AN APPEAL OF THE APPROVAL OF QUAIL MEADOWS APARTMENTS PROJECT

APPLICATION No. 6-ENC-25-0196
CDP-003761-2020

Approved Project

Figure 2 - Excerpt of Final Environmental Assessment Figure 4.3-2, Potential Jurisdictional Wetlands & Water

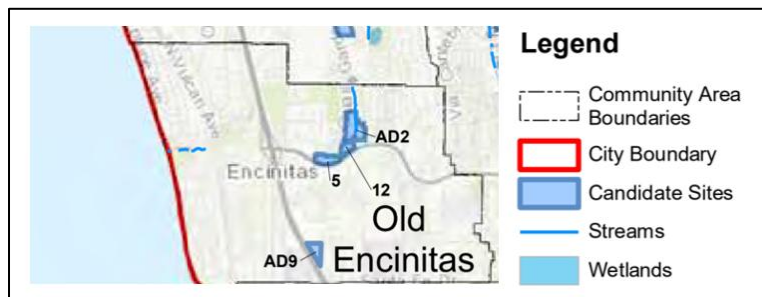
A well-documented blue line stream, identified on several resources as a tributary to Cottonwood Creek, enters the middle of the project to the north of the wetland area and travels south along its natural drainage course extending beyond the wetlands, eventually draining to an existing 84” reinforced concrete pipe at the south end of the property.

Surface water flows are impeded by the unpermitted headwall and 48” CMP within the wetland, which are also incapable of capturing the total surface water flows observed on the site as described in the project’s associated drainage technical report. The project also diverts flows exceeding the capacity of this CMP into a box culvert at the edge of the wetland area.

This blue line stream is identified as potential jurisdictional waters in several resources, including the 2018 City of Encinitas Final Environmental Assessment (Final EA)¹ prepared for analysis of all candidate Housing Element sites. This project is identified as candidate site AD2 in the Final EA. Specifically, the Biological Resources section of the Final EA states:

“Candidate Sites #11, #AD1, and #AD2 are adjacent to/contain a stream.” (*Final EA*, pg. 4.3-8)

A composite excerpt of Final EA Figure 4.3-2, Potential Jurisdictional Wetlands & Water and its legend is provided as Figure 2.

Due to the presence of this tributary to Cottonwood Creek and its natural drainage course, the project would be consistent with the LCP if it incorporated the drainage course into the design of the development, rather than divert its flows into the proposed box culvert at the edge of the wetland area.

Figure 3 – Excerpt of Final Environmental Assessment Figure 4.8-3, 303(d) List of Impaired Water Quality Segments and Legend

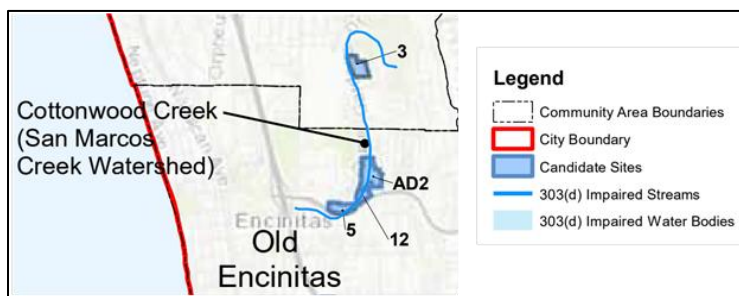
Figure 4.8-3 in the Final EA identifies 303(d) Impaired Water Bodies within the City of Encinitas and their candidate sites. This image shows Cottonwood Creek, including the tributary section flowing across the project site (AD2), as a listed impaired body. An excerpt of the figure identifying Cottonwood Creek as a 303(d)-listed impaired water body and its legend is provided as Figure 3

The project’s stormwater quality control plan includes two biofiltration basins (BMP-200 and BMP-300) leading to underground vaults at the far east and west portions of the wetland area bordering the development. However, as the project has not adequately identified this tributary of Cottonwood Creek nor its impaired status, we argue the project has not determined if the associated best management practices are sufficient to prevent additional contamination of 303(d)-listed water body Cottonwood Creek.
